Preliminary Assessment Report Nanticoke GS Replacement of Station Service Transformers

CAA ID 2001-046

Draft Report

Nanticoke GS, replacement of SST7, SST8, RSS3 and RSS4

FIGURE 1. Station Service Transformers Connectivity Nanticoke GS

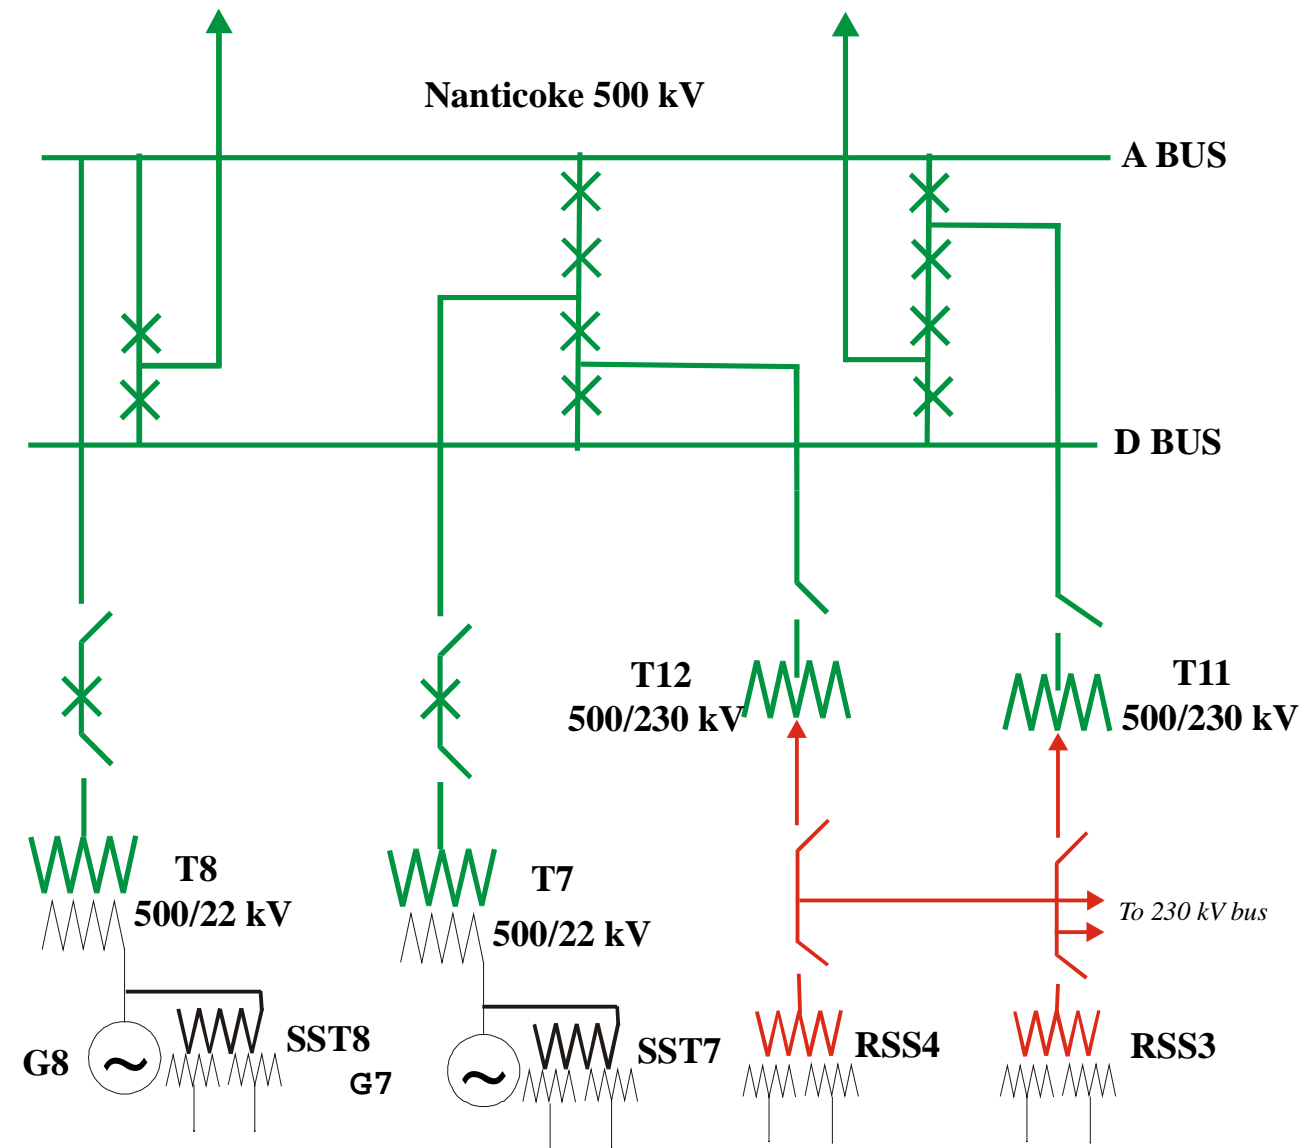
The new transformers will effectively be installed in the same location as the old transformers and the existing connectivity arrangement will be maintained. Figure 1 shows the electrical location and lists the ratings of the new transformers.

Projected station service load information, which includes the SCR load, has not been provided by OPG. However, based on the new equipment rating this load is not to exceed 43 MVA.

OPG must ensure that the rating of the remaining station equipment is adequate to support the increase in station service load due to the installation of the SCR.

If the station service load including the SCR is not sensitive to voltage variations , meaning that continued supply would be maintained for voltage between 4.59 kV to 3.94 kV then, the reserve station transformers do not have to be equipped with under-load tap changers. If, however this is not the case then, the reserve station transformers RSS3 and RSS4 must be equipped with under load tap changers.
